# Issue 21: Proposed improvements to the Classification objects from Neuchatel Group

## Neuchâtel and GSIM working together: A two part proposal

## Proposal from this group (purple indicates a change to object name or relationship)

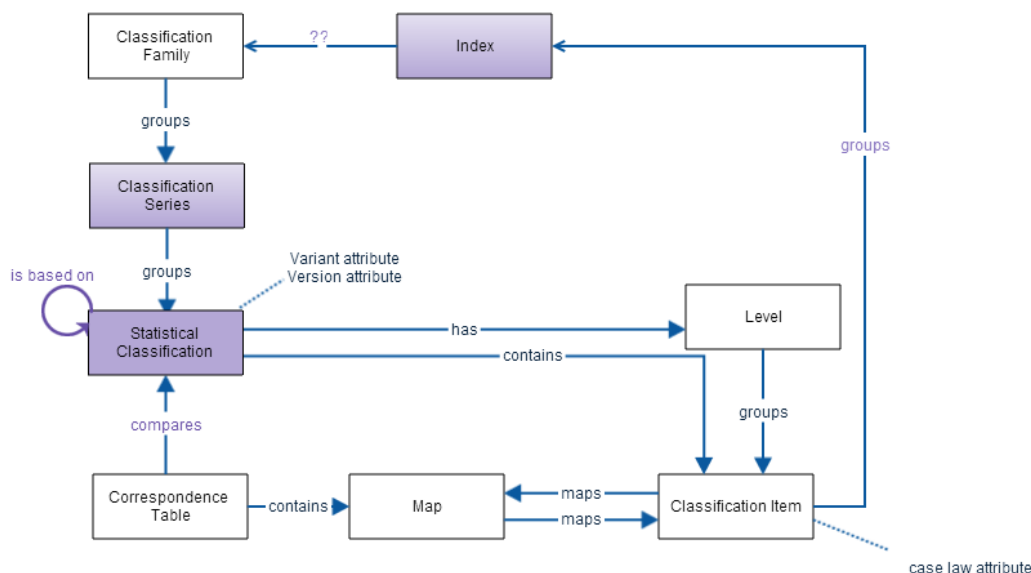
The proposal is outlined in the diagrams and tables below. Please note that the attributes and relationships pertaining to classification index entries is still being fine tuned by the group.

Detailed proposed changes to GSIM:

Current GSIM Object	Proposed change	Revised Name	Revised Definition	Revised Relationships
Classification Family	Change definition	Classification Family	<p><b>Definition:</b> A Classification Family comprises a number of Statistical classifications, which are related from a certain point of view. The family may be based on a common Concept (e.g. economic activity).</p> <p><b>Explanatory notes:</b> Different classification databases may use different types of Classification Families and have different names for the families, as no standard has been agreed upon.</p> <p><b>Source:</b> revised Neuchatel</p>	<p>A Classification Family groups Classification Series</p> <p>Potential relationship to Classification Index to be added</p>
Classification	Change name Change definition	Classification Series	<p><b>Definition:</b> A Classification Series is an ensemble of one or several consecutive Statistical Classifications under a particular heading (for example ISIC or ISCO).</p> <p><b>Explanatory notes:</b></p> <p><b>Source:</b> revised Neuchatel</p>	<p>A Classification Series groups Statistical Classifications</p>

Classification Scheme	<p>Change name</p> <p>Change definition</p> <p>Add attributes of version and variant</p> <p>Add self referential relationship</p>	Statistical Classification	<p><b>Definition:</b> A Statistical Classification is a set of categories (Classification Items) which may be assigned to one or more Units in statistical surveys or administrative files, and used in the production and dissemination of statistics.</p> <p><b>Explanatory notes:</b> The Classification Items are defined in terms of one or more characteristics of a particular Population of Observation Units. A statistical classification may have a flat, linear structure or may be hierarchically structured, such that all Classification Items at lower levels are sub-groups of the next Level up. The Classification Items at each level of the classification structure must be mutually exclusive and jointly exhaustive of all objects in the target population.</p> <p><b>Source:</b> David</p>	<p><i>A Classification Series groups Statistical Classifications</i></p> <p><i>A Statistical Classification can be based on a Statistical Classification</i></p> <p><i>A Statistical Classification has Classification Items</i></p> <p><i>A Statistical Classification has Levels</i></p> <p><i>A Correspondence Table compares a Statistical Classification</i></p>

Classification Version	<p>Remove from GSIM model</p> <p>Add as attribute of Statistical Classification</p>	--	--	--
Classification Version	<p>Remove from GSIM model</p> <p>Add as attribute of Statistical Classification</p>	--	--	--
Level	Revise definition	Level	<p><b>Definition:</b> A Statistical Classification has a structure which is composed of one or several Levels. A Level often is associated with a Concept, which defines it. In a hierarchical classification the Classification Items of each Level but the highest are aggregated to the nearest higher level. A linear classification has only one level.</p> <p><b>Explanatory notes:</b></p> <p><b>Source:</b> revised GSIM</p>	<p><i>A Statistical Classification has Levels</i></p> <p><i>A Level groups a Classification Item</i></p>

Classification Item	Change definition Add attributes of case law	Classification Item	<p><b>Definition:</b> A Classification Item represents a Category at a certain Level within a Statistical Classification. It defines the content and the borders of the Category. A Unit can be classified to one and only one item at each level of a Statistical Classification.</p> <p><b>Explanatory notes:</b></p> <p><b>Source:</b> revised Neuchatel</p>	<p><i>A Statistical Classification has Classification Items</i></p> <p><i>A Map maps to a Classification Item</i></p> <p><i>A Level groups a Classification Item</i></p>
Map	Revise definition	Map	<p><b>Definition:</b> An expression of the relation between a Classification Item in a source Statistical Classification and a corresponding Classification Item in the target Statistical Classification.</p> <p><b>Explanatory notes:</b> The map should specify whether the relationship between the two categories is partial or complete</p> <p><b>Source:</b> revised GSIM</p>	<p><i>A Correspondence Table contains a Map</i></p> <p><i>A Map maps to a Classification Item</i></p>

Correspondence Table	Change definition	Correspondence Table	<p><b>Definition:</b> A Correspondence Table expresses the relationship between two Statistical Classifications</p> <p><b>Explanatory notes:</b> These are typically: two versions from the same Classification Series; Statistical Classifications from different Classification Series in the same Classification Family; a variant and the version on which it is based; or, different versions of a variant. In the first and last examples, the correspondence table facilitates comparability over time. Correspondence relationships are shown in both directions.</p> <p><b>Source:</b> Revised Neuchatel</p>	<p><i>A Correspondence Table contains a Map</i></p> <p><i>A Correspondence Table compares a Statistical Classification</i></p>

----	Add new object	<p>Classification Index</p> <p>(the group is still discussing exactly what this object should be - including the exact definition, attributes, explanatory text and relationships)</p>	<p><b>Definition:</b> A Classification Index is a list of words or text strings (e.g. the name of a locality, an economic activity or an occupational title and task) that refer to Classification Items in one or more Statistical Classifications from the same Classification Family.</p> <p><b>Explanatory notes:</b> A Classification index shows the relationship between text found in statistical data sources (responses to survey questionnaires, administrative records) and one or more Statistical Classifications. A Classification index may be used to assign the codes for classification items to observations in statistical collections. A Classification Index may be presented in alphabetical order of the text, in code order, or searched electronically.</p> <p><b>Source:</b> Revised Neuchatel</p>	<p>To Be Confirmed</p> <p>A <i>Classification Index</i> groups <i>Classification Items</i></p> <p>A <i>Classification Index</i> [ something ] a <i>Classification Family</i></p>
